McCULLOCH SERVICE BULLETIN

NO. 1579

MODEL S 250, S 550, SP 125C, SP 105, PM 105 DATE November 25, 1974

SUBJECT CLUTCH PROTECTOR PLATE

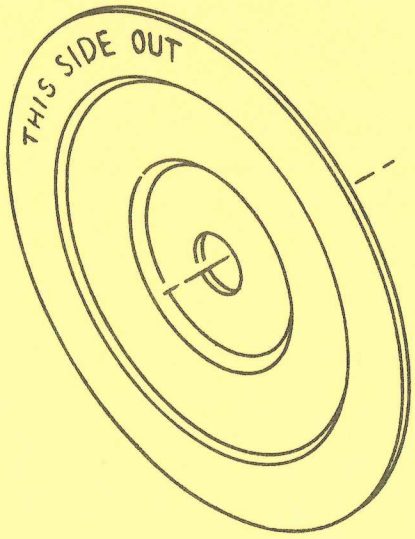
A new Clutch Protector Plate, P/N 91055, is now being installed on all current models of the above listed saws.

The purpose of the protector plate is to prevent the entry of sawdust or other foreign material to the clutch or to the interior of the clutch drum. The plate also serves as a heat and spark shield if the saw is improperly operated with excessive clutch slippage.

We recommend that you advise customers that the protector plate is available as they come in to have their units serviced, and suggest that they have one installed to provide the protection described above.
